Palmdev Pty Ltd  
BCA Design Assessment Report

1112 – 1116 Barrenjoey Road  
Palm Beach NSW 2108

Project: 1112 – 1116 Barrenjoey Road Palm Beach NSW 2108  
 Document Type: BCA Design Assessment Report  
 Our Reference: P221\_249-2 (BCA) DY

**Figure 2.2 – RIS and effective height**

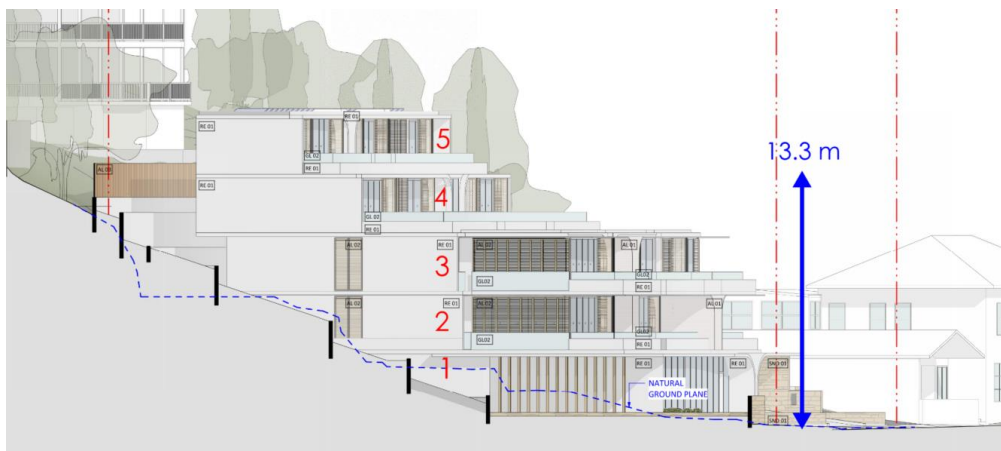
The building is determined to have a RIS of five (5), as the building is setback from allotment boundaries, RIS is the greatest number of storeys above the finished ground plane.

Similarly, effective height is measured from the lowest storey included in RIS i.e. Ground floor.

Figure C3D7 (a) & C3D7 (b)

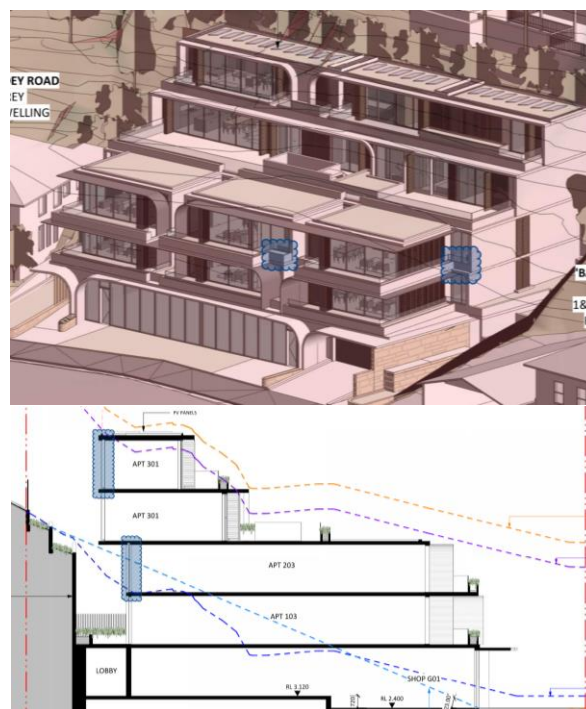
**Note** – The building is required and assumed to be sprinklered throughout, this clause is only applicable if the system is FPAA101D or FPAA101H

**Spandrels** – The provision of spandrels within the external walls not less than 900mm in height and extend not less than 600mm above the finished floor level. The spandrels are required to be non-combustible and have an FRL being not less than 60/60/60; or

The figure below indicates openings where protection is not provided.

**E3D3 Stretcher facility in lifts (Prev. E3.2)**

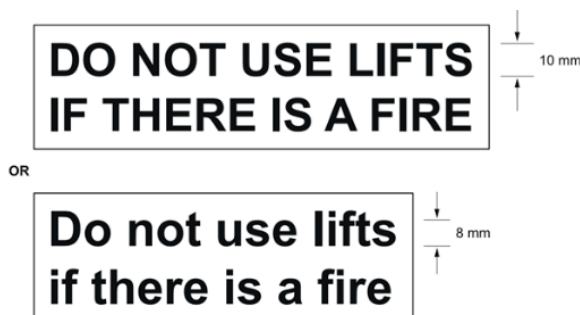
A stretcher facility is required to be provided to Lift 1, on the basis the passenger lift serves storeys above an effective height of 12 m.

A stretcher facility must accommodate a raised stretcher with a patient lying on it horizontally by providing a clear space not less than 600 mm wide x 2000 mm long x 1400 mm high above the floor level.
